# SUBSURFACE WASTEWATER DISPOSAL SYSTEM APPLICATION

<b>PROPERTY ADDRESS</b>	
Town Or Plantation	Augusta
Street or Vision Lot #	Old Belgrade Road
<b>PROPERTY OWNERS NAME</b>	
Last: N.R.F. DISTRIBUTORS INC.	
Applicant Name:	% Dave White
Mailing Address of Owner/Applicant (if Different)	P.O. Box 2967 Old Belgrade Rd. Augusta, Me

Subject: Replacement System Variance to the Maine Subsurface Wastewater Disposal Rules, N.R.F. Distributors property, Old Belgrade Road, Augusta

**SUBSURFACE WASTEWATER DISPOSAL PLAN**

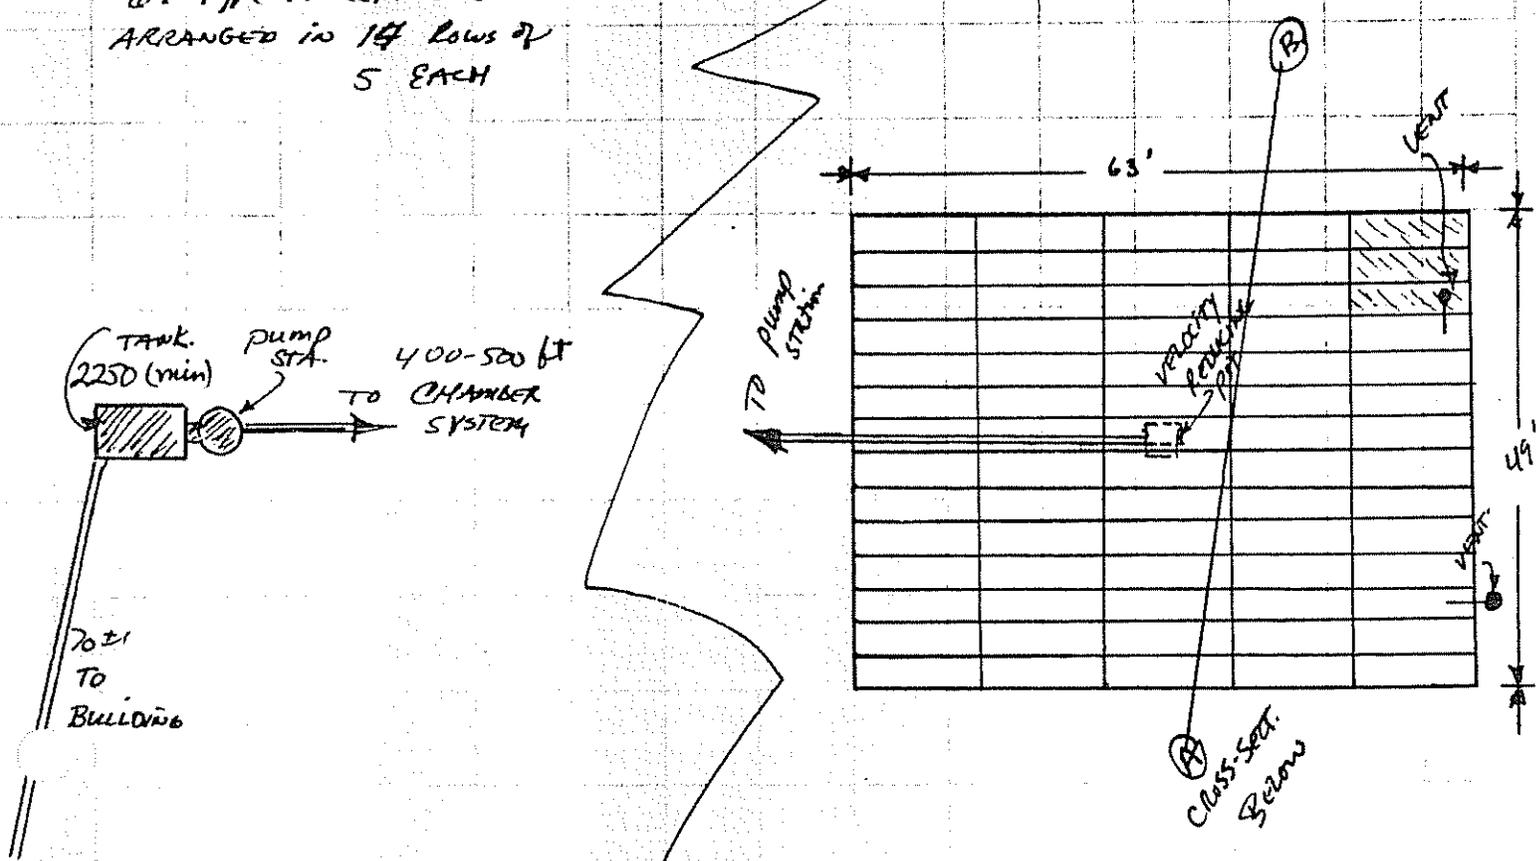
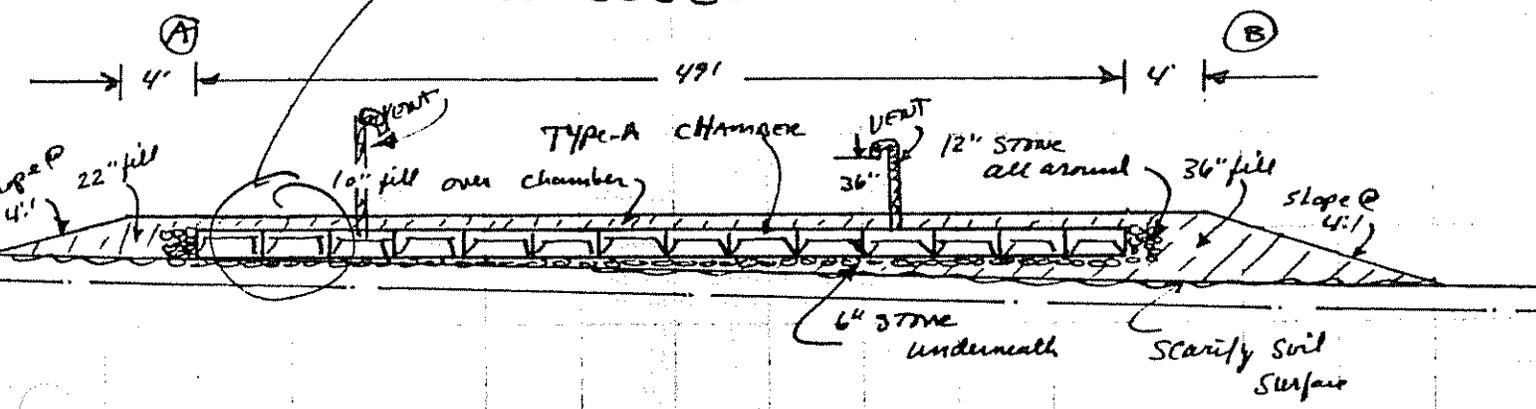
A completed HHE-200 Form by Stephen Goodwin SE.; a completed HHE-204 Form signed by Stephen Goodwin, SE., and Robert St. Pierre, LPI. The above is accepted as a complete application for variance to the Subsurface Wastewater Disposal Rules. A replacement subsurface disposal system cannot be installed on the subject property in full compliance with the Rules because of the installation of a cluster of 67 type 'A' chamber units with a total bottom area of at least 3000 square feet on category 8D soils with a seasonal high water table at 10-14 inches, the reasons for the variance request.

The installation of a 2250 gallon septic tank followed by a lift station pumping to a cluster of 67 type 'A' chamber units with a total bottom area of at least 3000 square feet at a dose of at least 500 gallons.

At least 22 inches and 36 inches of fill shall be applied on the uphill and downhill sides of the disposal field, respectively. The fill shall be of a texture similar to the original soil and will provide a 12 inch separation between the bottom of the disposal bed and the seasonal high water table and impervious layer. The fill must be extended in all directions as required by Section 11.D of the Subsurface Wastewater Disposal Rules.
